LDO & LSO GARAGE DOOR OPERATOR OPEN LIMIT SWITCH ADJUSTMENT

IMPORTANT BULLETIN - FIELD ACTION REQUIRED

How to identify affected products:

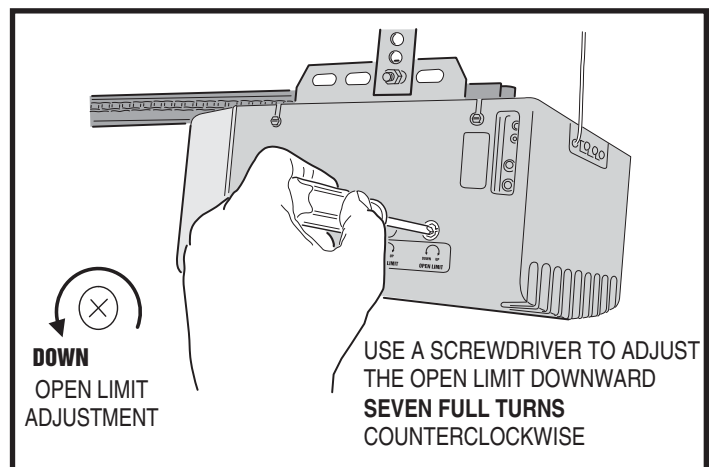
This bulletin applies to all Linear Model LDO & LSO garage door operators manufactured from December 3rd, 2007 to April 6th, 2008. Products manufactured between these dates have the preset factory location of the open limit adjustment set abnormally high. This can affect operator setup and testing in 7-foot and 8-foot rail installations.

The date of manufacture is stamped on the outside of the operator's packing box above the product identification label. If the product has already been corrected at the factory, a light blue dot will be seen on or near the label. Operators produced after April 7th, 2008 have the correct preset open limit setting and no field action is required.

To prevent possible damage to the operator and/or rail components, BEFORE APPLYING POWER TO THE OPERATOR, turn the OPEN LIMIT adjustment screw downward (counterclockwise) seven (7) full turns. This will return the operator to the normal factory setting. After adjusting, FOLLOW ALL PRINTED INSTRUCTIONS supplied with the operator.
